**Brookhaven National Laboratory  
Plant Engineering - E&CS Division  
Engineering Change Notice Form**

**PROJECT:** CCWF II

**ECN Title:** IPS Piping Class

**ECN No.** 65

A STEAM AND CONDENSATE FLOW DIAGRAM  
 NO SCALE

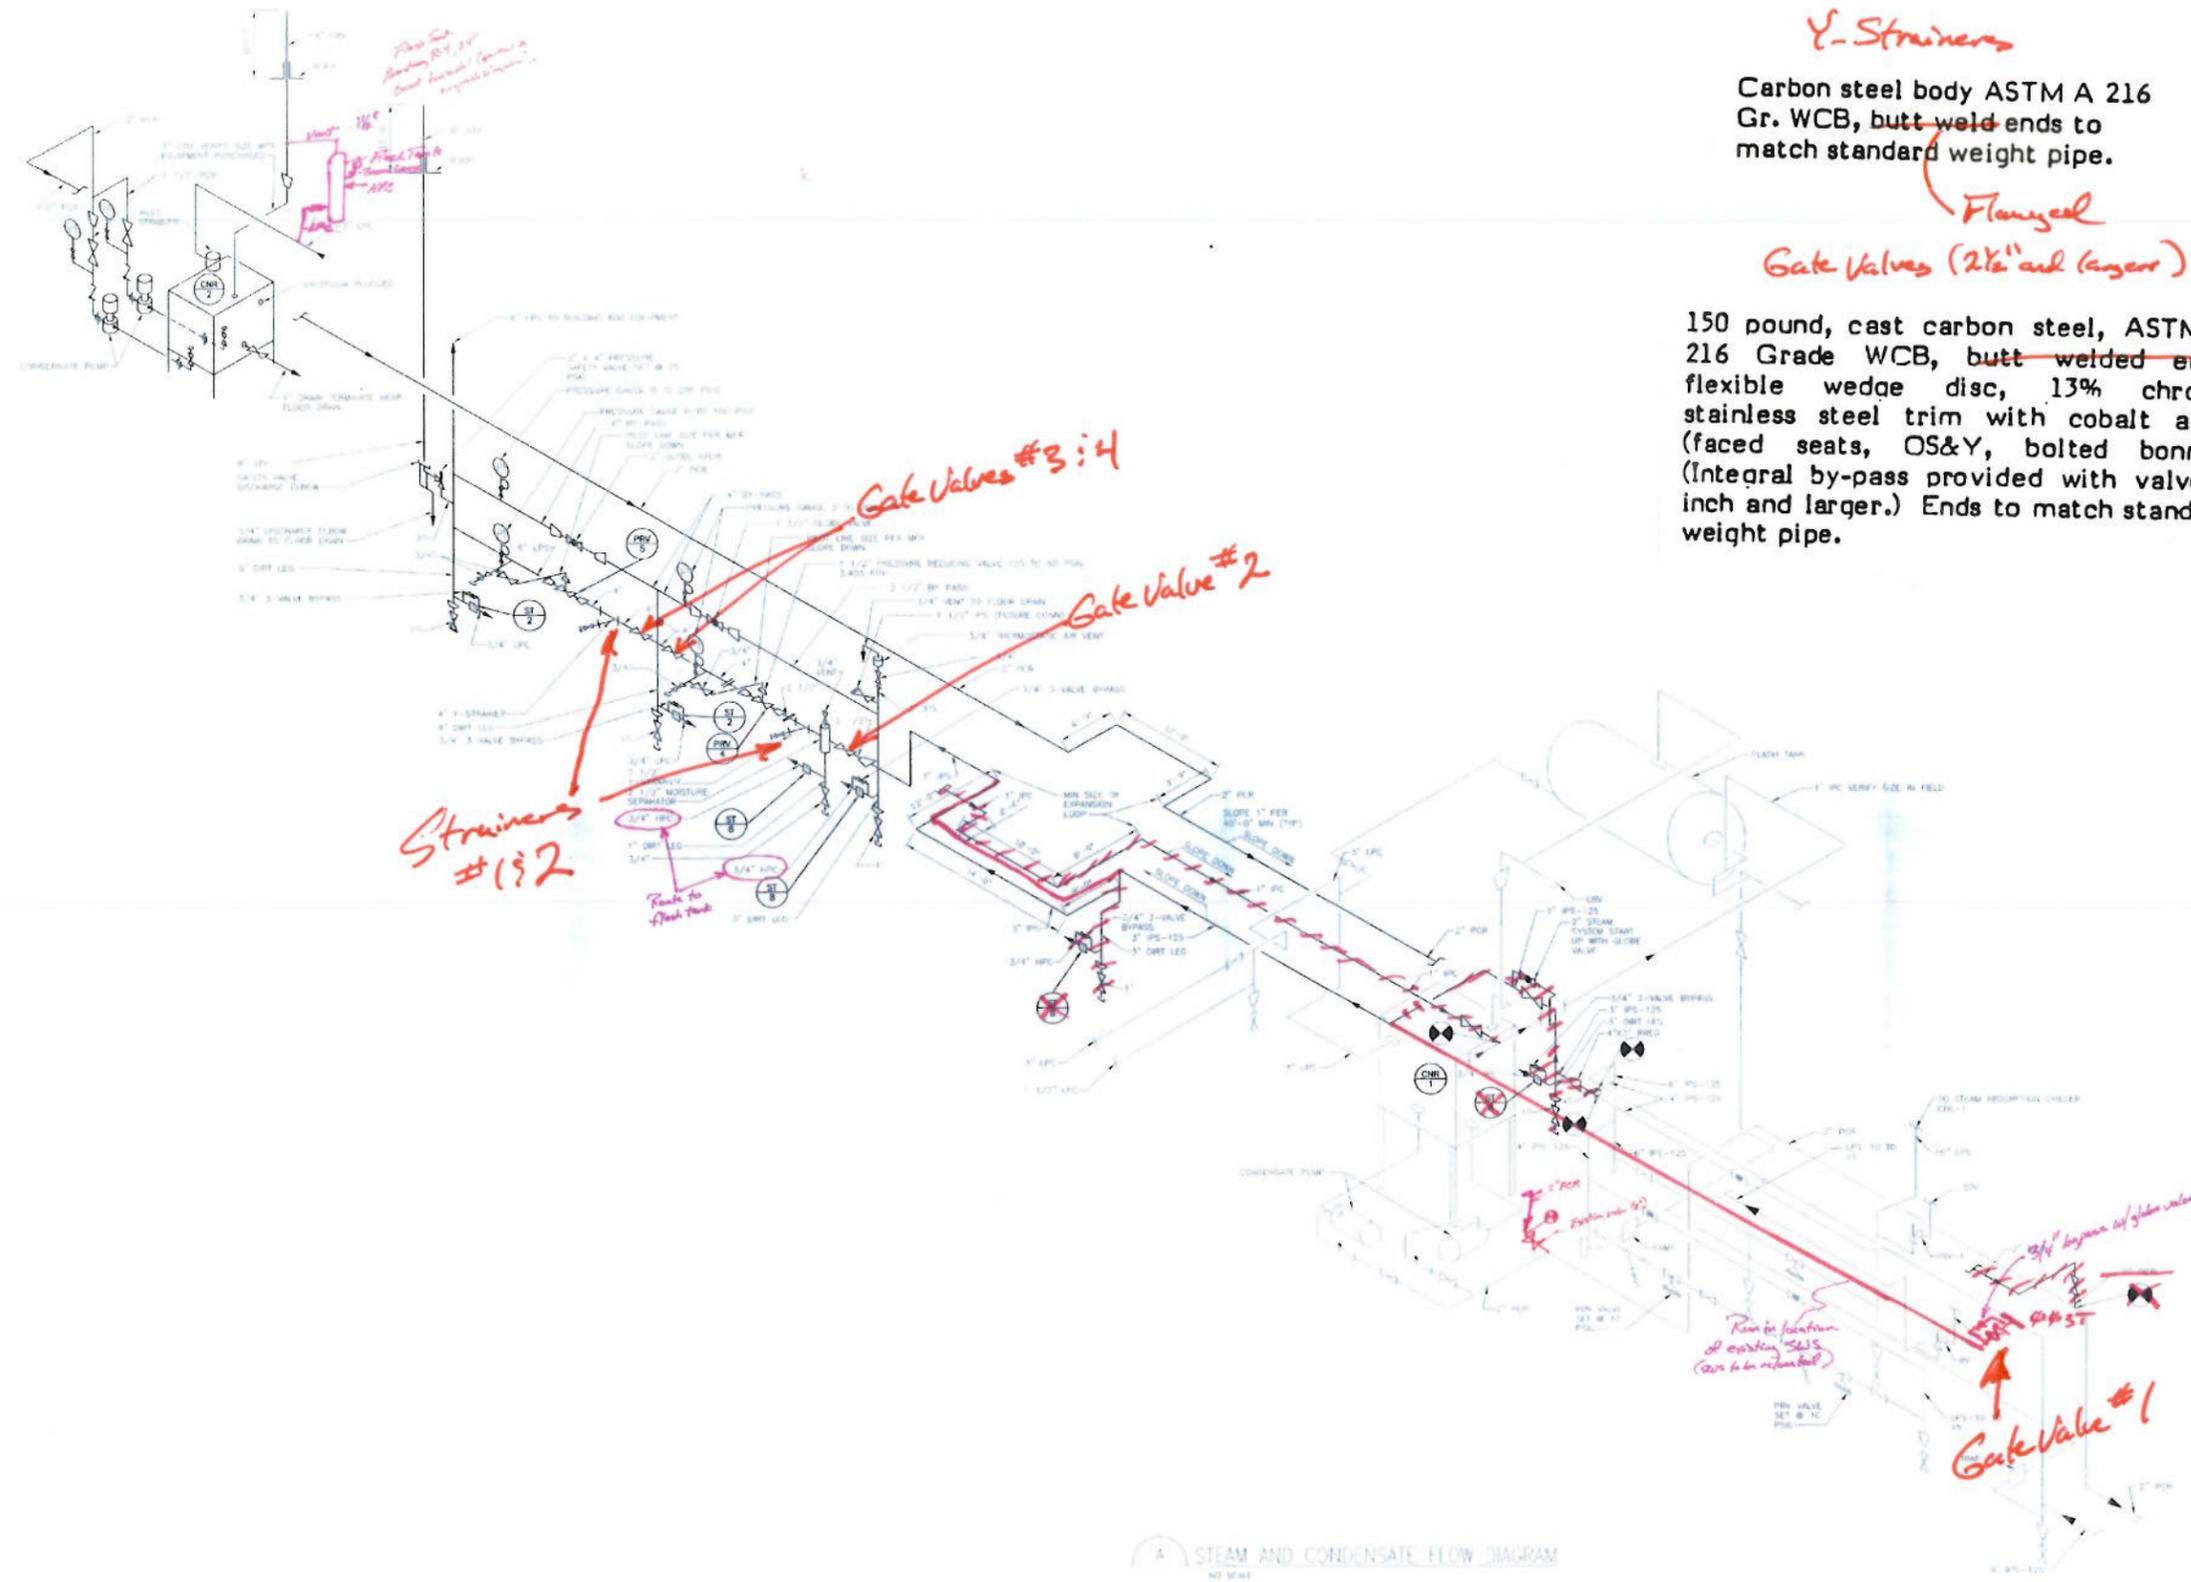
Requested Change (Attach sketch if applicable): Change 2 1/2" and over IPS valves and strainers to piping Class 150 to meet BNL standard specification requirements.

Resolution: See attached drawing with strainer and valve specifications.

*Y-Strainers*  
 Carbon steel body ASTM A 216  
 Gr. WCB, butt-weld ends to  
 match standard weight pipe.

*Flanged*  
 Gate Valves (2 1/2" and larger)

*Flanged*  
 150 pound, cast carbon steel, ASTM A  
 216 Grade WCB, butt-welded ends,  
 flexible wedge disc, 13% chrome  
 stainless steel trim with cobalt alloy  
 (faced seats, OS&Y, bolted bonnet.  
 (Integral by-pass provided with valve 6  
 inch and larger.) Ends to match standard  
 weight pipe.
